UNITED STATES PATENT AND TRADEMARK OFFICE

APPLICATION NO.	FILING DATE	FIRST NAMED INVENTOR	ATTORNEY DOCKET NO.	CONFIRMATION NO.
10/540,661	06/23/2005	Gregory John Neighbours	4502-1086	2900
<small>465</small> YOUNG & THOMPSON 209 Madison Street Suite 500 ALEXANDRIA, VA 22314			<small>7590</small> EXAMINER FIGUEROA, ADRIANA	
			<small>3633</small> ART UNIT	PAPER NUMBER
			05/12/2008 MAIL DATE	PAPER DELIVERY MODE

Office Action Summary

1. Applicant's election without traverse of Group I, "a system, a method and a jack for lifting a concrete slab" in the reply filed on 01/10/2008 is acknowledged.

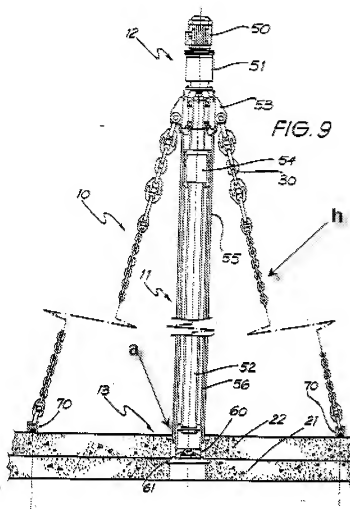
Regarding claim 1, Neighbours discloses a system of lifting and conveying a concrete slab (22) and any associated works, wherein the slab has a plurality of apertures (a) therethrough the slab area, (Figure 1, annotated Figure 9), the said apertures being provided with a respective jack (10), said jack at least comprising at least one shaft (11) having a portion passing through said aperture and contacting a lower support means (40, 41), (Column 5, Lines 1-8), means (30, 51, 53, 55) for connecting said slab to said shaft, (annotated Figure 9),

the connection means incorporating at least one supporting member (30) connecting the slab (22) to the shaft (11), and means (50) for effecting longitudinal travel of said supporting means (30, 51, 53, 55) along said shaft, otherwise resulting in the raising or lowering of said slab, (annotated Figure 9), position sensors associated

Regarding claim 2, Neighbours discloses the jack (10) including trailing restraint means (55, 56) being adapted to provide restraint and or stability for the jack once it has climbed or the jack has been disconnected from the slab, (Figure 9), (Col 6, Lines 66-67, Column 7, Lines 1-3).

Regarding claim 7, Neighbours discloses each supporting member (30) engages with the upper face of the slab (22), (Figure 9).

Regarding claim 8, Neighbours discloses each jack (10) having pivoting means (p) such that in use each jack can accommodate displacement of the jack whereby there is a minimum transfer of moment through any tensile members, (annotated Figure 9).

Regarding claim 25, Neighbours discloses a jack (10) for lifting a concrete slab (22) , the jack including: at least one shaft (11) and ball screw (52), a drive assembly (12), a hanger assembly (h), a support device(40, 41) wherein the drive assembly drives the ball screw to raise the shaft with respect to the hanger assembly wherein, the support device supports the shaft to prevent toppling and provide stability, (Figure 1, annotated Figure 9).

Regarding claim 26, Neighbours discloses the drive assembly (12) further drives the ball screw (52) to raise the hanger assembly (h) with respect to the shaft (11) such that in use the jack has lifted a slab (22), (annotated Figure 9).
